RE: TREE PROTECTION PLAN FOR 2040 ARROWSMITH DRIVE, OTTAWA

DRAWING: Tree Protection Plan

PROJECT: 2040 ARROWSMITH DRIVE
CITY OF OTTAWA

RESPONSES TO CITY COMMENTS

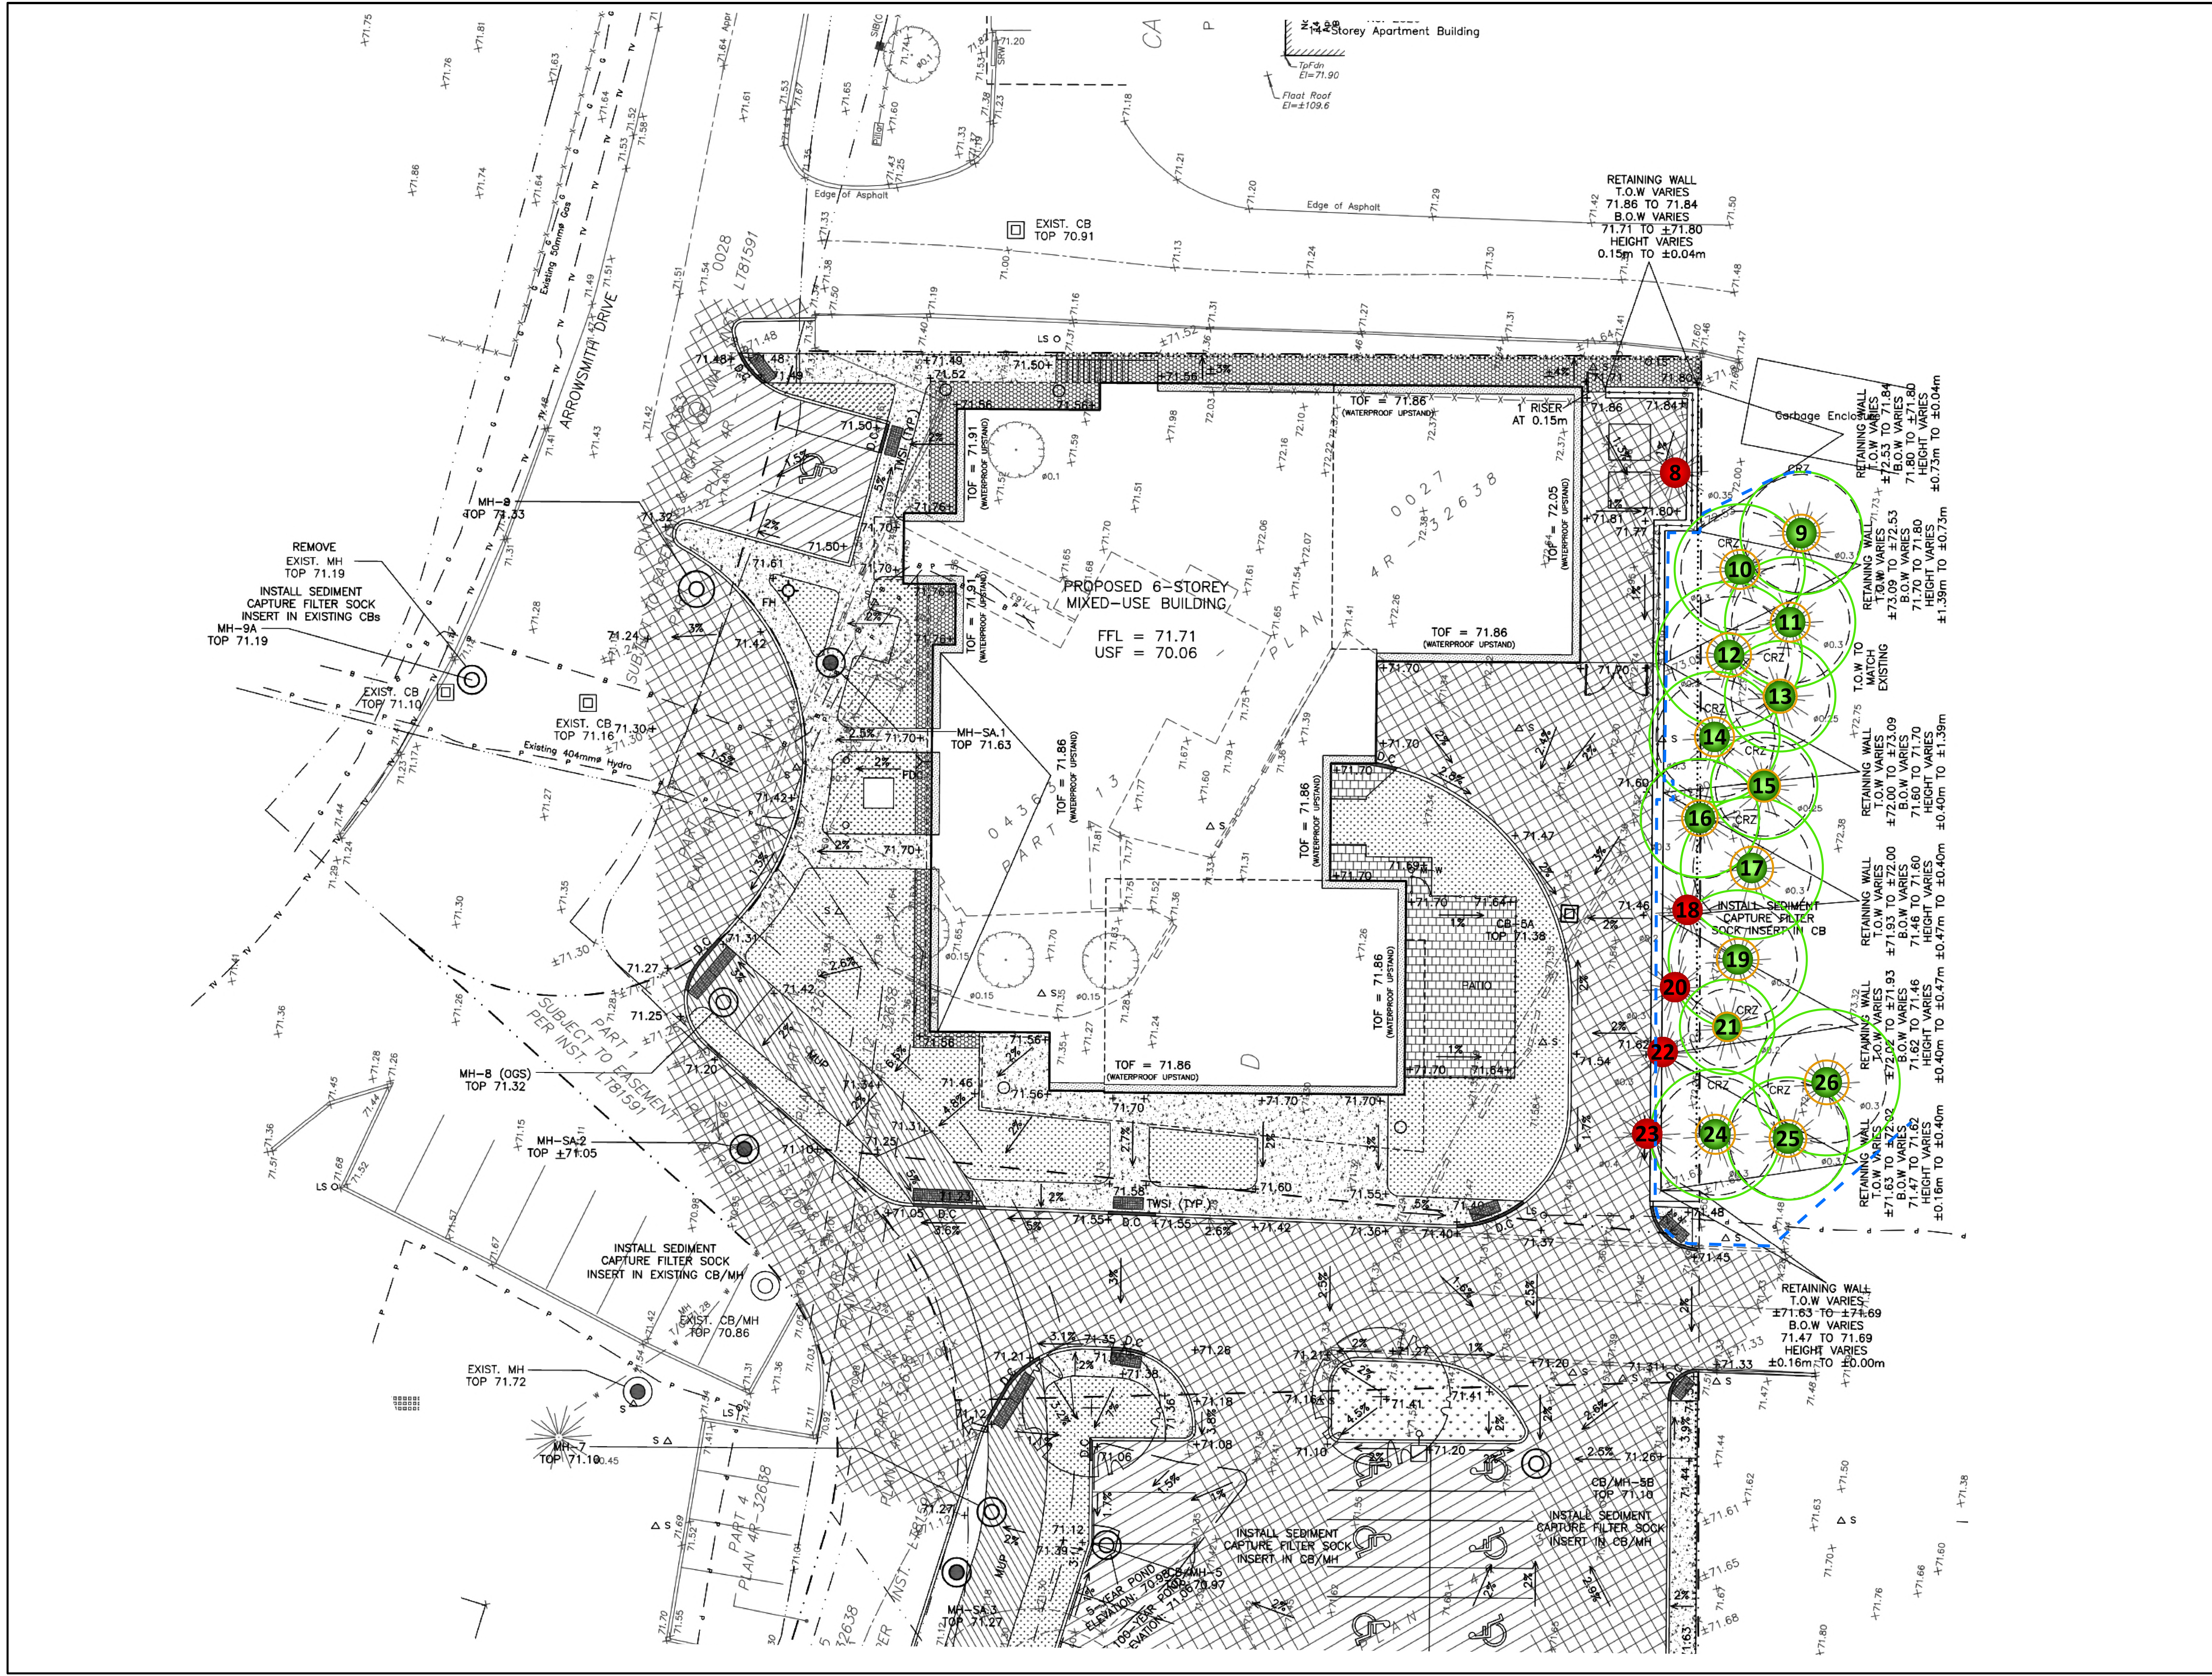
1b) *What extent of impact to the CRZs of these retained trees will occur and will it cause retained tree health to decline? Will there be excavation within the static root zone of the tree (Diameter x 3)?*

1g) *The consulting engineer and RPF must discuss the grade changes proposed along the eastern edge of the site. The trees are growing on a berm. A retaining wall, curb and access road will be installed along the edge of this growing space. Identify the implications of this work in the plan.*

At most, 30% of one tree’s CRZ (tree #16) will be impacted by grading. This equals the maximum recommended in ISA best management practices. As shown in the plan on page 7, no static root zones will be impacted.

The consulting engineer and forester have discussed the implications of the work proposed along the eastern edge of the site. Grading behind the proposed retaining wall remains as existing. Approximately 30% of the CRZ of tree #16 will be impacted while lesser amounts of the CRZs of trees #10, 12, 14 and 24 will be impacted.
